## HISTORIC AND DESIGN REVIEW COMMISSION

**HDRC CASE NO:** 2022-202  
**ADDRESS:** 221 VANCE ST  
**LEGAL DESCRIPTION:** NCB 733 BLK 5 LOT 16  
**ZONING:** R-6 H  
**CITY COUNCIL DIST.:** 1  
**HIST. DIST. NAME:** Lavaca  
**APPLICANT:** SCOTT T MARTIN  
**OWNER:** SCOTT T MARTIN  
**TYPE OF WORK:** New construction of accessory buildings  
**APPLICATION RECEIVED:** March 27, 2022  
**60-DAY REVIEW:** Not applicable due to City Council Emergency Orders  
**CASE MANAGER:** Jessica Anderson

The applicant is requesting a conceptual approval to construct a 437-square-foot accessory structure and 160-square-foot screened porch.

SITE PLAN D

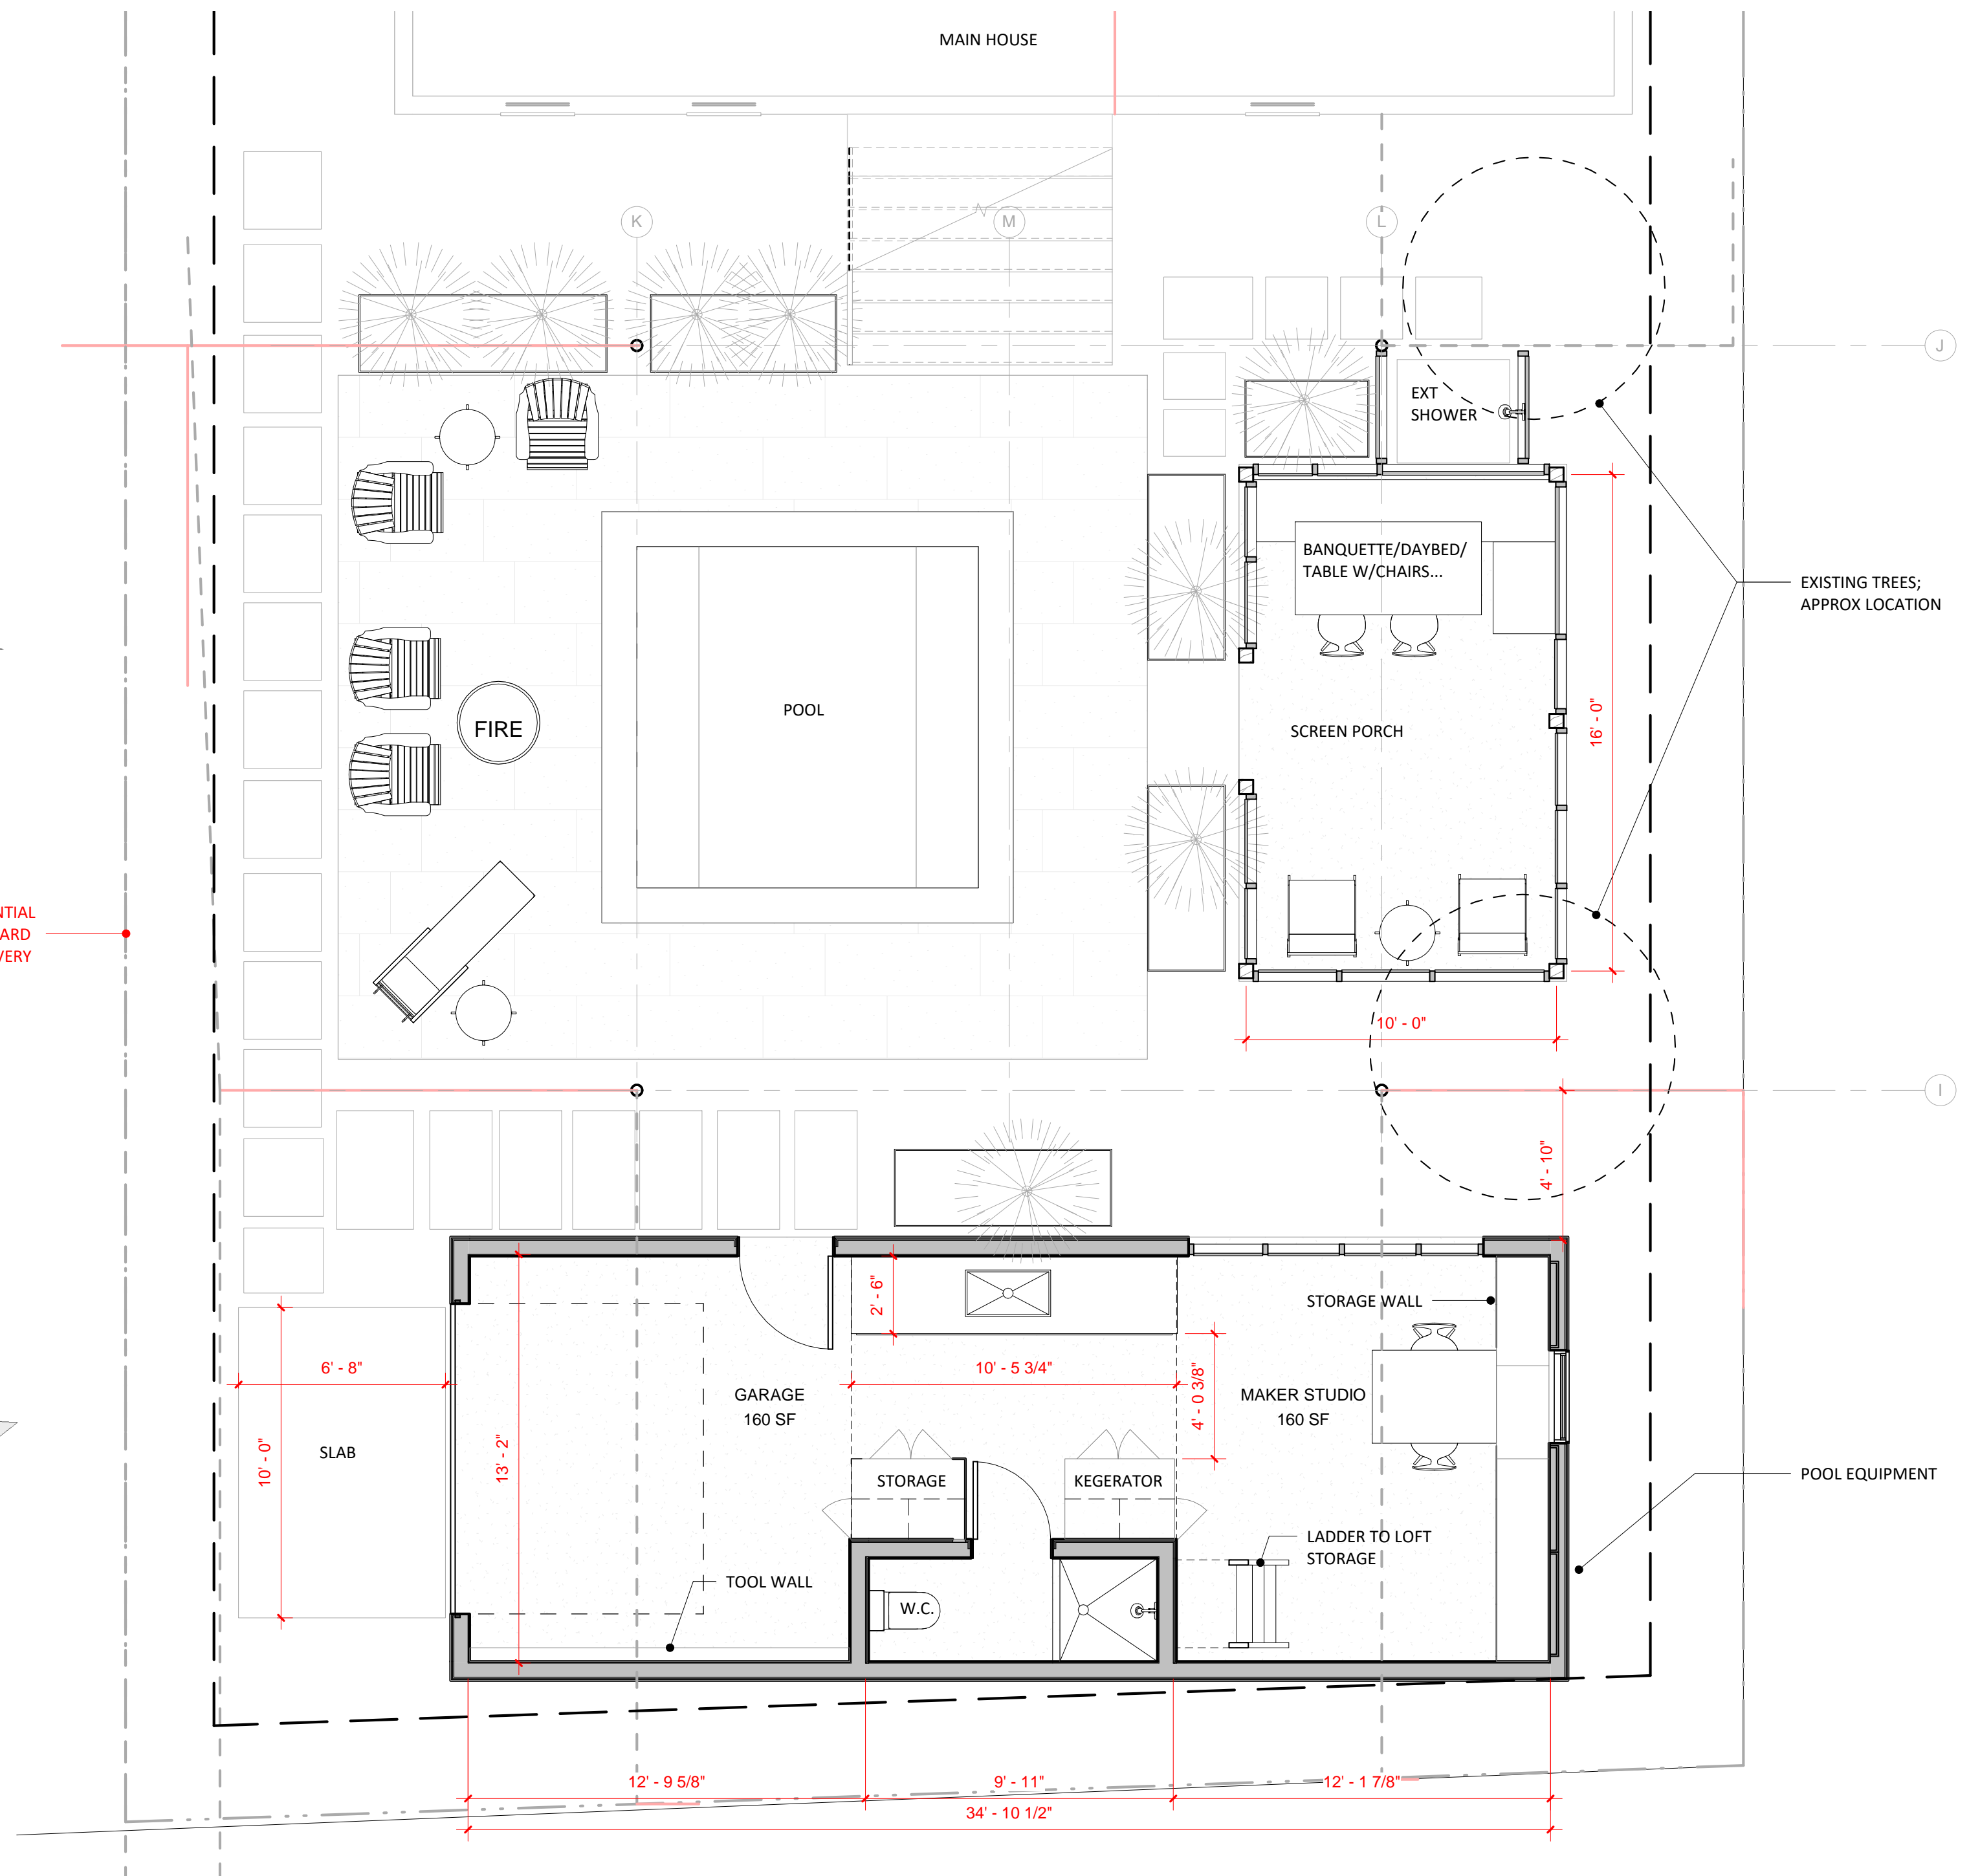
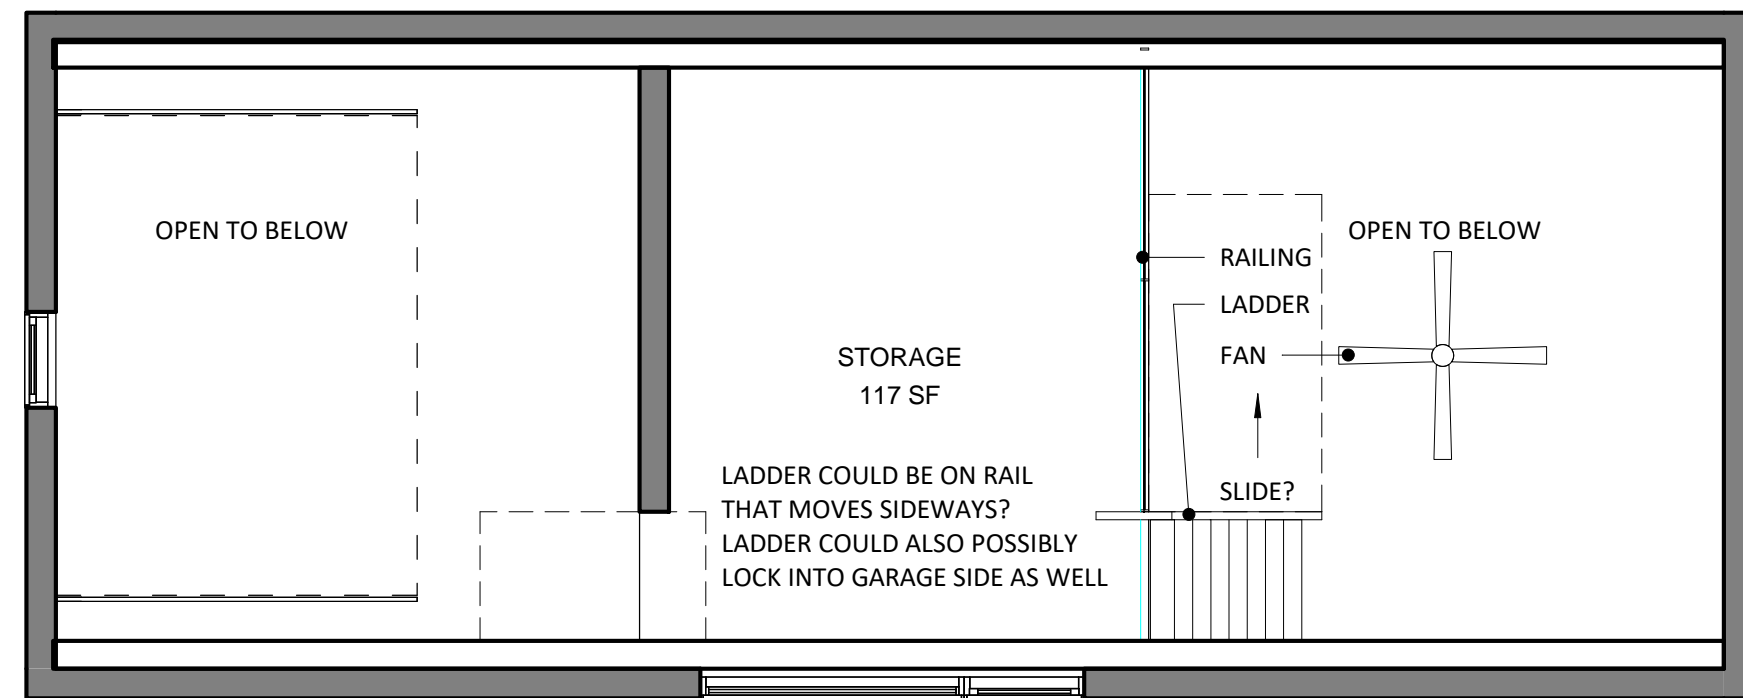
- b. **ACCESSORY STRUCTURE:** The Guidelines for New Construction 5.A. notes that new garages and outbuilding should be visually subordinate to the primary historic structure in terms of their height, massing, and form, and should be no larger in plan than forty percent of the primary historic structure's footprint. The existing structure on the lot features a footprint of 1,895 square feet and one story in height. The proposed accessory structures feature a total footprint of 597 square feet. Staff finds the proposed height and general massing to be subordinate to that of the primary historic structure. However, staff finds that the applicant should submit a full site plan and construction drawings that include the primary structure to better illustrate the relationship between the primary structure and the proposed accessory structures.

- c. **ORIENTATION & SETBACKS:** The applicant has proposed both an orientation and setbacks that are consistent with the Guidelines for New Construction 5.B.

- i. That materials submitted for final approval include a full site plan and constructions drawings that include the primary structure.
- ii. That the applicant proposes window profiles for the smaller fixed windows that have more traditional proportions and operable sashes and that proposed windows otherwise meet the Standard Specifications for Windows in Additions and New Construction.
- iii. That the applicant propose a fully wood garage door or a garage door with a design that mimics wood construction and features a smooth finish without a faux wood grain texture. Final garage door specifications must be submitted to staff for review and approval prior to the issuance of a Certificate of Appropriateness.

EXTERIOR  
ELEVATIONS

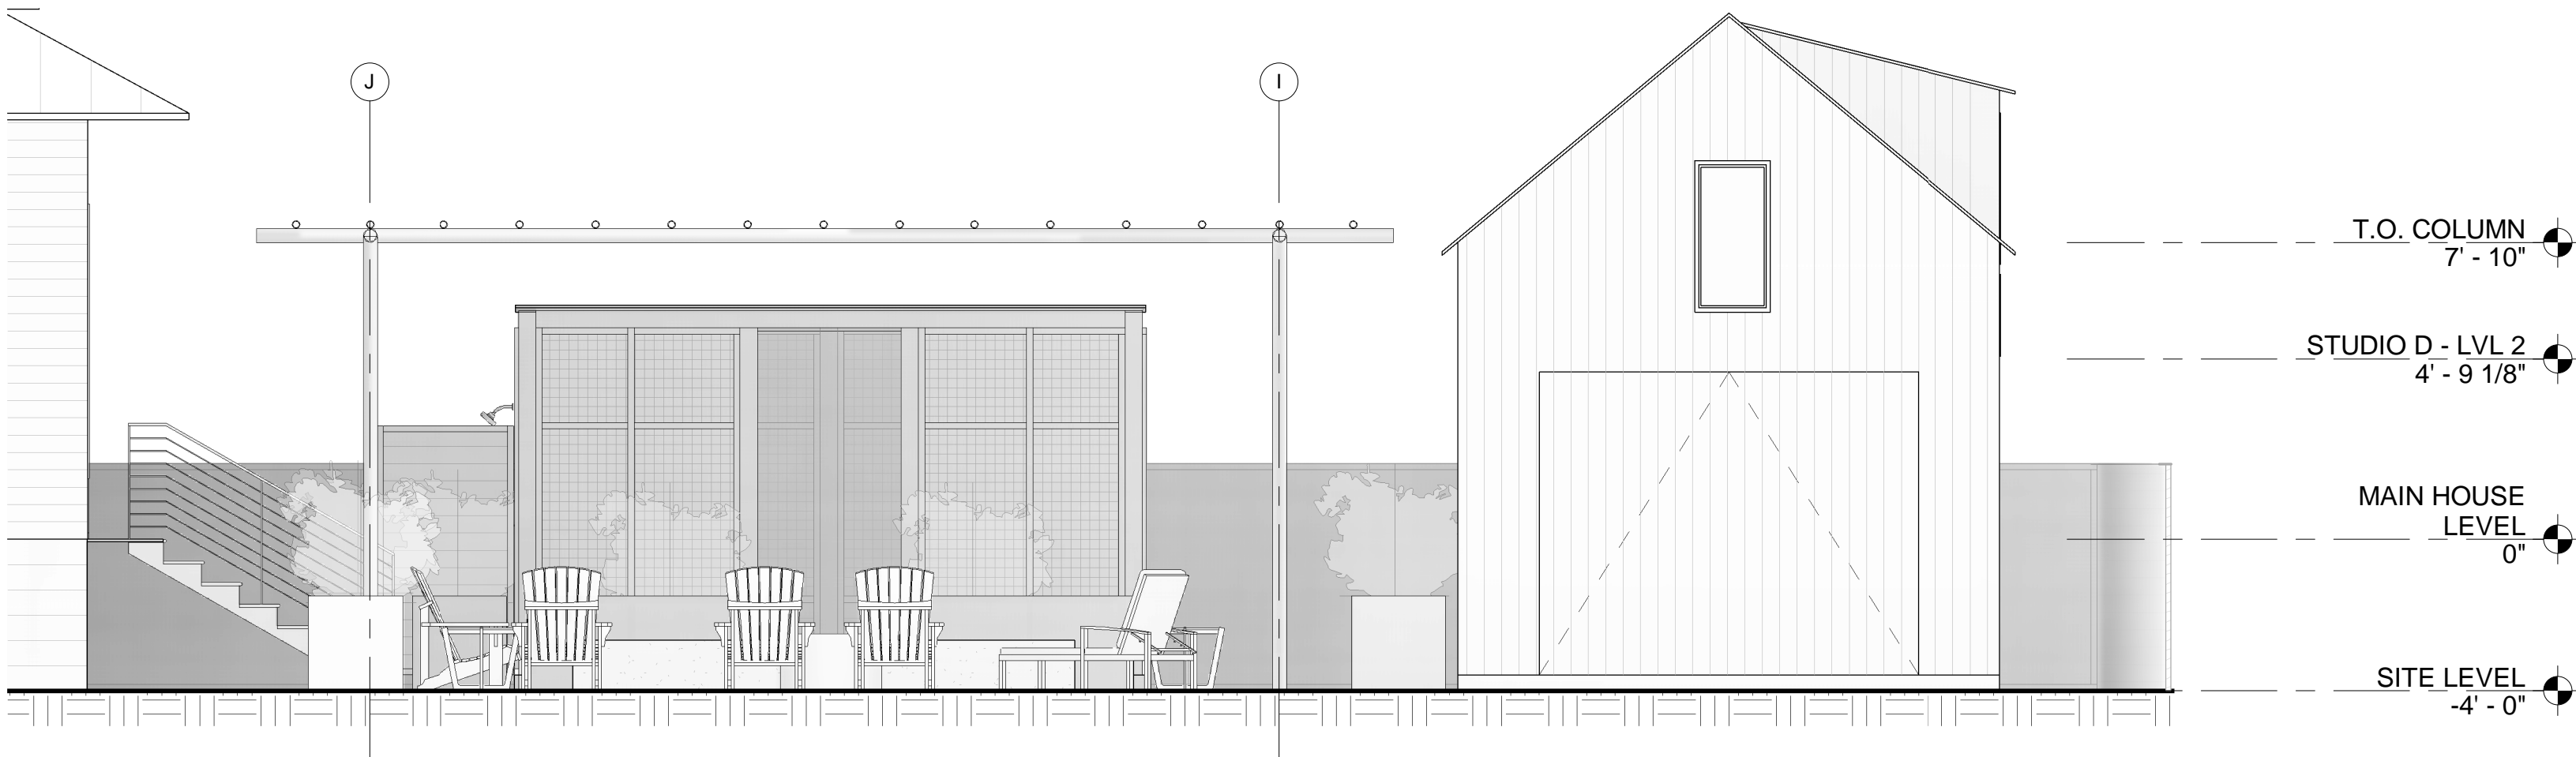
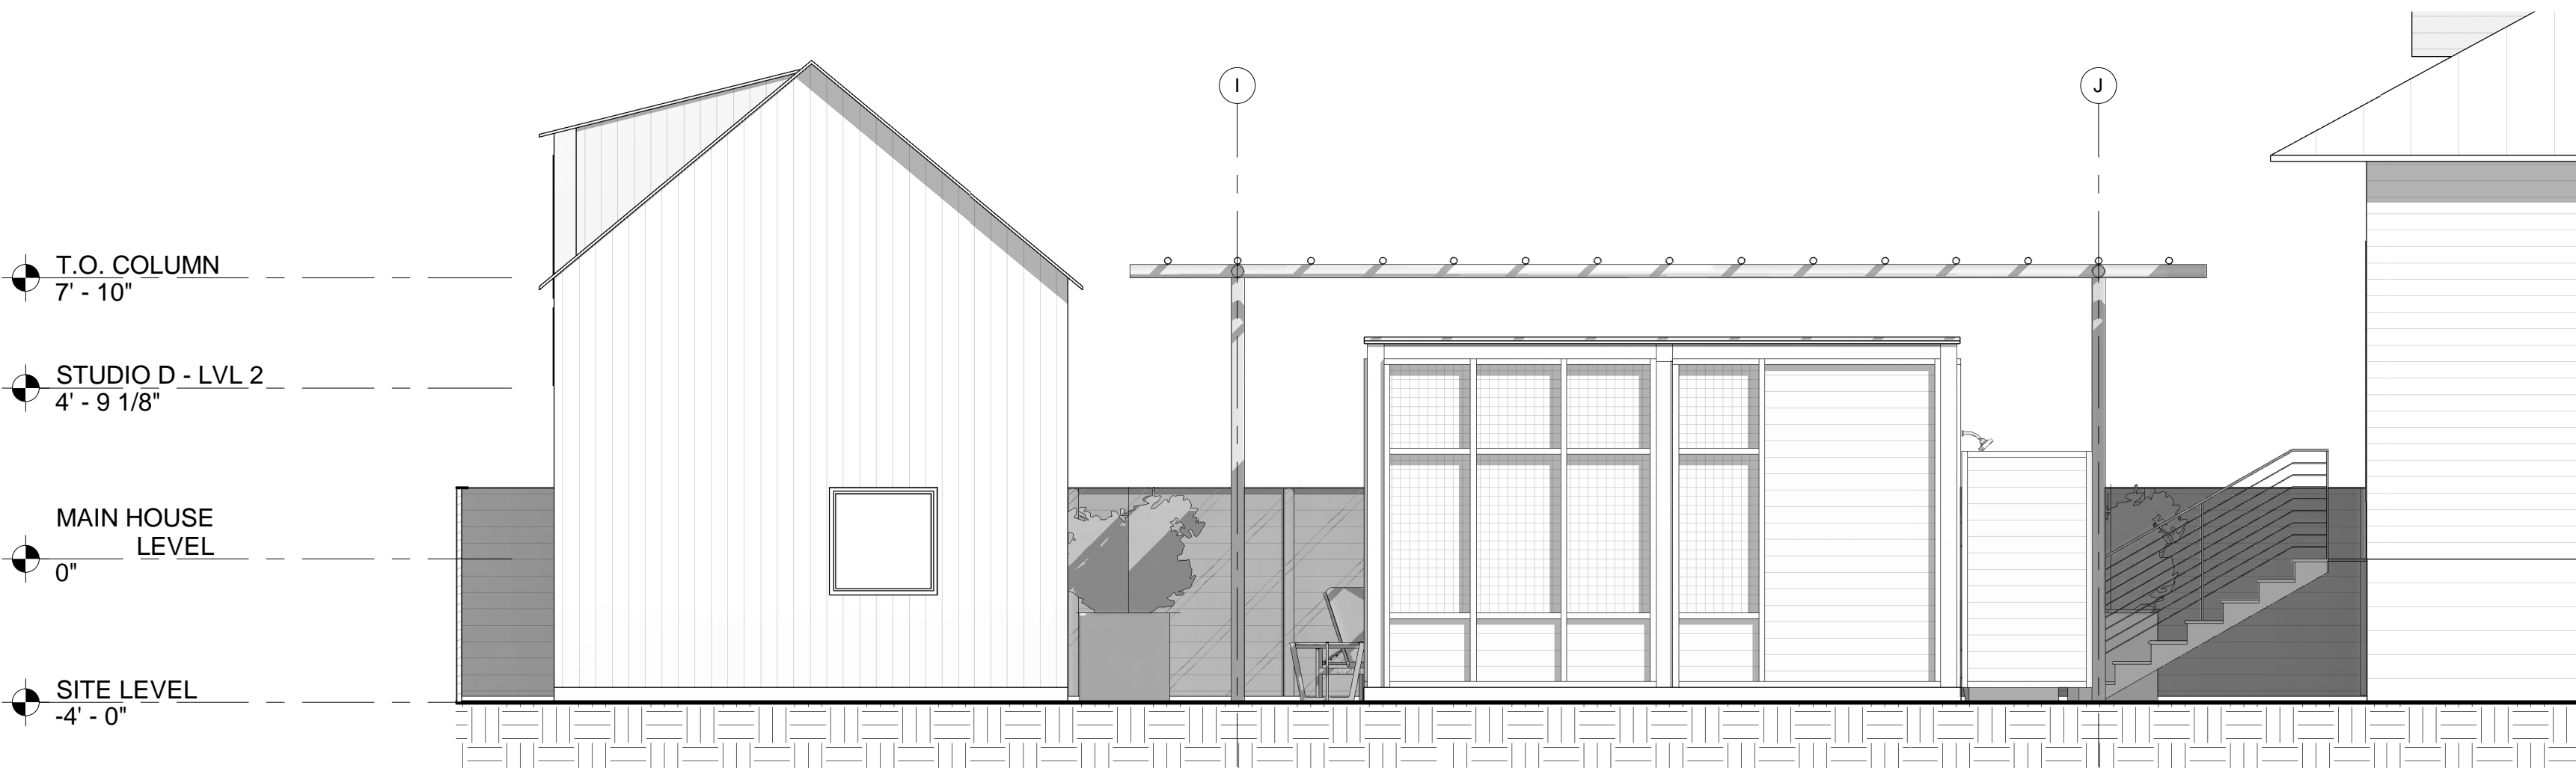
- d. **ARCHITECTURAL DETAILS (Materials):** The Guidelines for New Construction 5.A.iii. and iv. note that new accessory structures should relate to the period of construction of the primary historic structure on the lot through the use of complementary materials and simplified architectural details. The applicant has not yet determined final materials but proposes using historically appropriate materials that fit into the neighborhood. Staff finds that lap siding with a four (4) inch exposure would be appropriate to relate to the horizontal wood siding of the primary historic structure, and any composite siding should feature a smooth finish. Guideline 5.A.v for New Construction states that garage doors should be incorporated with similar proportions and materials as those traditionally found in the district. Staff finds that a fully wood garage door or a composite material with a design that mimics wood construction and features a smooth finish without a faux wood grain texture would be most appropriate.

- e. **WINDOWS:** The applicant proposes a single-lite square window on the west elevation, a single-light gable window above the garage door on the east elevation, a grid of fixed windows on the south elevation, and clerestory windows on the north elevation. Windows on the primary historic structure are predominately rectangular one-over-one operable wood windows. Per Standard Specifications for Windows in Additions and New Construction, new windows on additions should relate to the windows of the primary historic structure in terms of materiality and overall appearance. Windows used in new construction should be similar in appearance to those commonly found within the district in terms of size, profile, and configuration. Staff finds the proposed window profiles are not consistent with these specifications.
